The staff report states:

"The brick portion of the building the applicants are proposing to demolish was likely constructed during the period of significance, but we have no records for the date of construction. It is a very simple design and clearly separated from the more ornate original portion of the house."

1892 Sanborn map

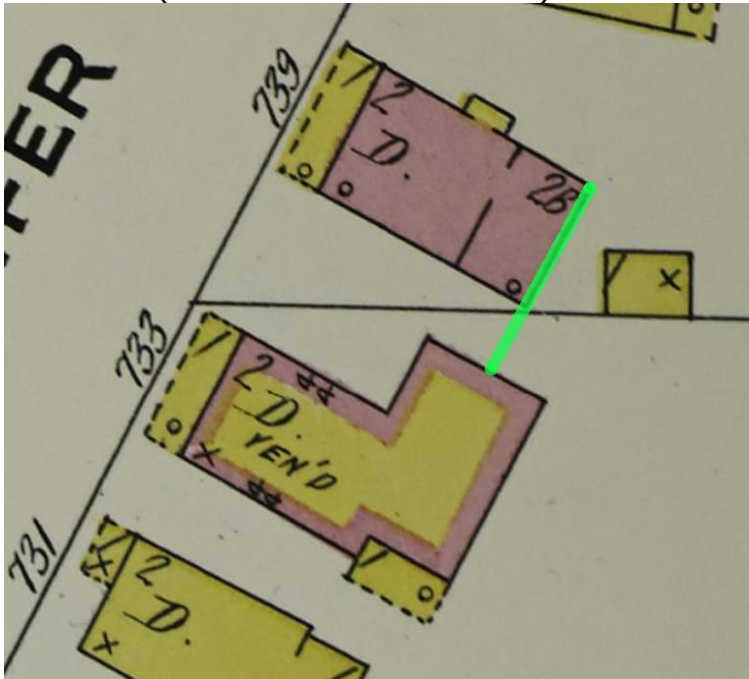
This Sanborn map of 1892 reflects that the addition already existed by 1892. The pink of 739 shows that the entire home is brick (unlike the pink outline at 733 which reflects a brick veneer). The yellow at the front with a dotted line along Jenifer is a porch and the yellow at the side is a bay window. There is a line, with a break in the line, which reflects the interior brick wall. Page 17 of the applicant's materials reflects the line in the exterior brick where the addition meets the original portion of the house. That line in the brick corresponds to the line (with the break) within the house.

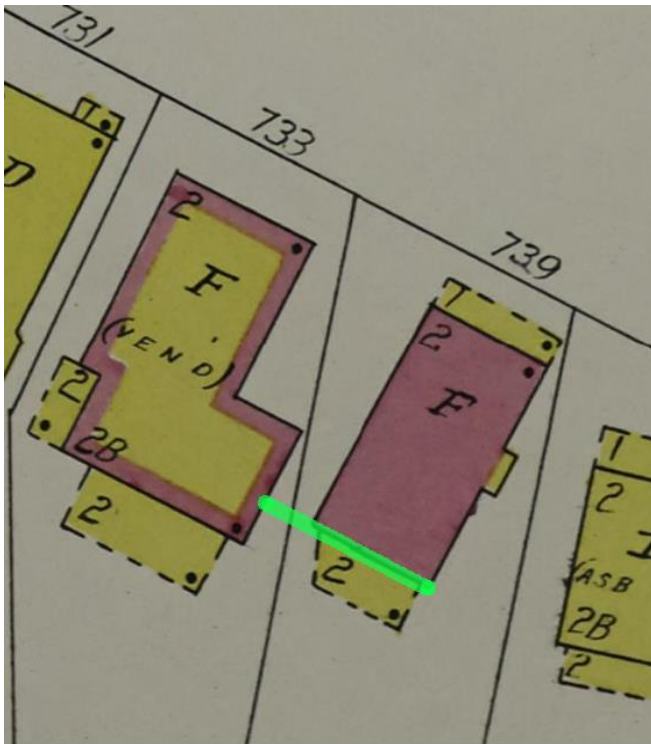
This Sanborn map from 1942 shows the same relationship (added green line) between 739 and 733 that existed in 1908. The difference is that a 2 story porch had been added at the back sometime after 1908.

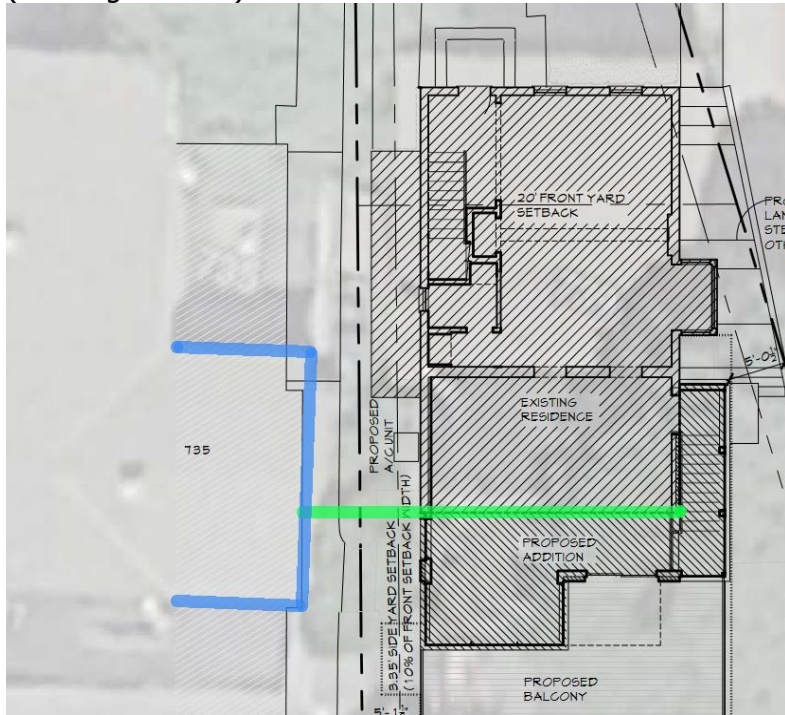
This image, from the applicant's 2025 application (Legistar 88974) shows the same relationship (added green line) between 739 and 733 that existed in 1908 and 1942.
